May 8, 2020

Project No. 19119232

**RE: RESPONSE TO TCEQ APPROVAL WITH COMMENTS LETTER DATED APRIL 23, 2020
PENTACHLOROPHENOL SOIL ASSESSMENT INTERIM REPORT DATED MARCH 30, 2020
UNION PACIFIC RAILROAD COMPANY – HOUSTON WOOD PRESERVING WORKS
HOUSTON, HARRIS COUNTY, TEXAS
HAZARDOUS WASTE PERMIT/COMPLIANCE PLAN NO: 50343, ISWR NO 31547
EPA IDENTIFICATION NO TXD000820266; RN100674613/CN600131098**

FIGURE

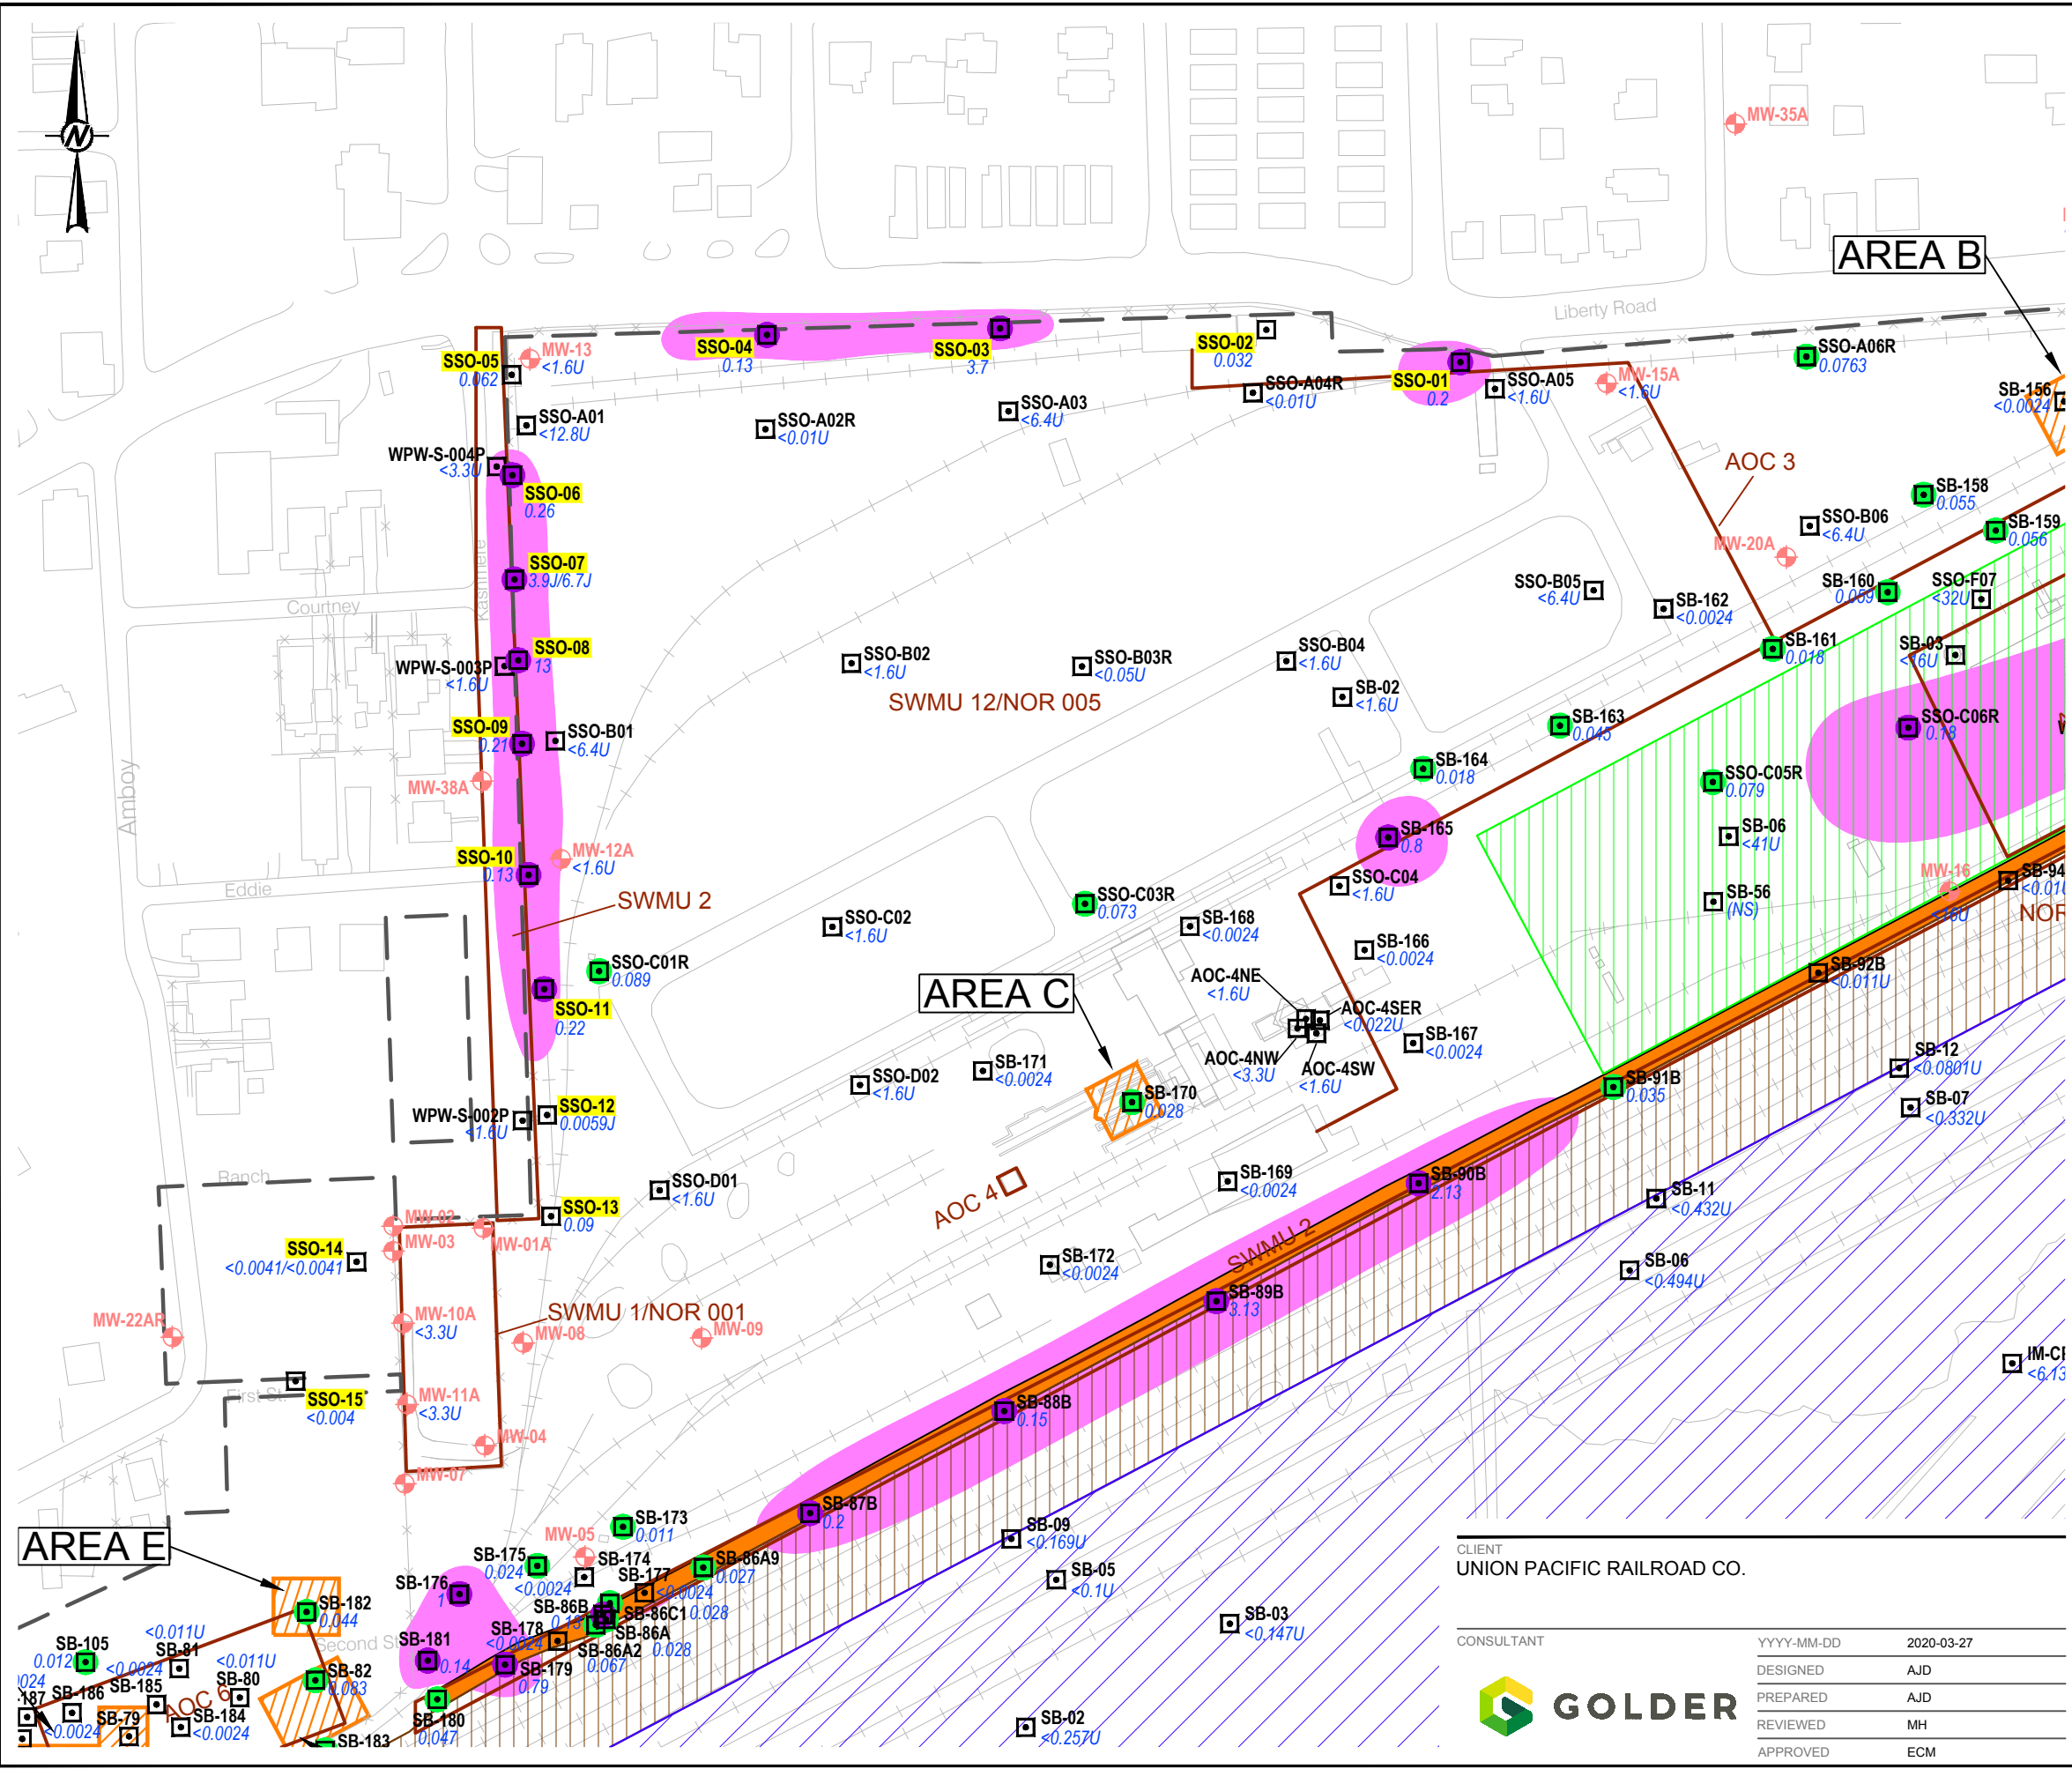
2. *Based on review of the PCP soil assessment results, additional soil sampling is necessary to delineate PCP concentrations off-site to ^{Total}Soil_{Comb} residential PCLs. Additional soil and/or groundwater sampling may be necessary to address the PCP Tier 2 ^{GW}Soil_{Ing} PCL exceedances discussed above. Please include step-out soil sampling locations to ensure that the extent of the impacted soil is delineated. Soil samples should be collected using a similar approach as described in the Report and should be analyzed for PCP.*

Response: Based on the PCP Report results, UPRR proposes to conduct additional soil sampling activities on-site and off-site with the following assessment objectives: 1.) evaluate the lateral extent of PCP concentrations in surface soils off-site where PCP concentrations in surface soil samples collected on-site along the property boundary exceeded the residential ^{Tot}Soil_{Comb} PCL; and 2.) evaluate the soil to groundwater pathway through a Tier 3 PCL evaluation by assessing potential leachability of PCP from surface soils in areas where the highest PCP concentrations from the February 2020 sampling activities were detected. The proposed additional soil sampling activities for the two objectives are detailed below.

As detailed in the PCP Report and shown on the attached Figure 1, three soil samples collected on-site near the property boundary at SSO-03 (along the northern perimeter), SSO-07, and SSO-08 (along the western perimeter) had PCP concentrations that exceeded the residential ^{Tot}Soil_{Comb} PCL of 0.73 mg/kg. To assess the lateral extent of PCP concentrations in surface soil off-site to the residential ^{Tot}Soil_{Comb} PCL, surface soil samples are proposed to be collected in the following areas (shown on attached Figure 1):

- North of the Site – Five soil borings are proposed to be sampled within the City of Houston right-of-way (ROW) north of the Site near on-site location SSO-03. The City of Houston ROW is approximately 8 to 10 feet in width between the UPRR fence line and the southern street curb for Liberty Road. The area is covered with soil and vegetation. The five proposed soil boring locations will be spaced approximately 50 feet from each other extending to the west and east from SSO-03. As feasible, proposed soil borings will be drilled and sampled between

the fence line and the curb for Liberty Road. Utility maps indicate an underground natural gas pipeline may be present near this area, and as a result, proposed locations may be modified following the necessary underground utility locate one-calls.

- West of the Site – The off-site area within the City of Houston ROW between the western fence line of the Site and Kashmere Street consists of an unlined storm water drainage ditch approximately 2 feet in depth and 15 feet in width that runs from Eddie Street along Kashmere and ends at Liberty Road. The drainage ditch between the UPRR property and Kashmere Street appears to flow to the north to near Liberty Road. The proposed additional soil sampling to delineate PCP concentrations to the residential $T^{ot}Soil_{Comb}$ PCL near SSO-07 and SSO-08 consists of soil borings to be sampled within the drainage ditch in the City of Houston ROW. UPRR proposes to drill and sample six transects of three soil borings each stepped out across the drainage ditch at the following locations:

- Within two feet of the UPRR fence line,
 - At the bottom or centerline of the drainage ditch, and
 - Within two feet of Kashmere Street.

A cross section showing the approximate locations of the proposed soil borings across the drainage ditch is provided on Figure 1. Some of the proposed locations may need to be adjusted (or potentially eliminated) based on accessibility/field conditions (e.g., underground utilities). These six transects of three soil borings each across the drainage ditch will be spaced approximately 50 feet apart within, north, and south of the SSO-07 and SSO-08 area.
